SEWAGE DISPOSAL TESTING
STATE OF MARYLAND - DEPARTMENT OF HEALTH AND MENTAL HYGIENE

PROPERTY OWNER Daisy United Methodist Church
ADDRESS Daisy Road, Woodbine, Md. Herbert Harriday
PHONE Work; 489-4151

ROAD AND DESCRIPTION Daisy Road - 1/2 mile south of Mullinix Motors

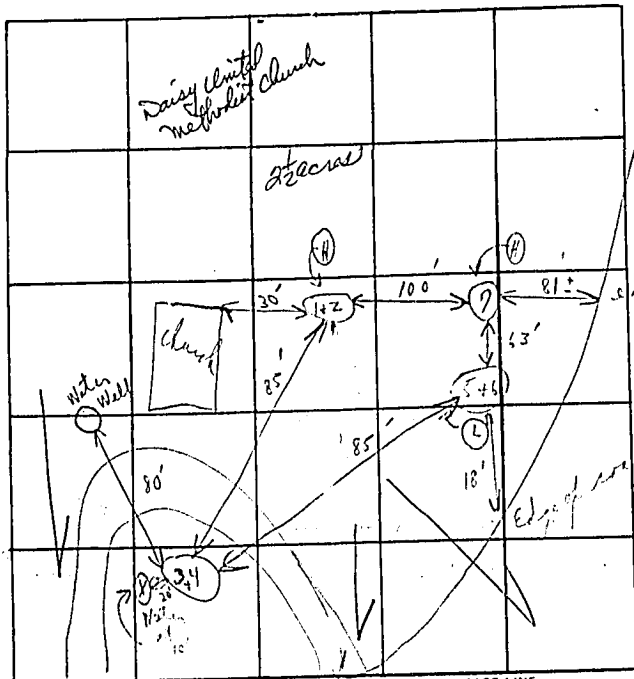
2 - 60' trenches off of septic tank
toward pers holes (1+2) + (7) with 20'-25' between
trenches!! 6' of gravel under pipe & pipe
inlet to trench to be from 2' - 3 1/2' from septic tank.
Requires 2 inspections!! (1st open trench
2nd after pipe & gravel in)

REASONS FOR REJECTION OR HOLDING 6/5/75 Hold for specs due to need
for a check on what will be response of in
system (?) kitchen & test room on just entrance (?)
No of kitchen need grease trap!! C.B.D. per D.W.M.
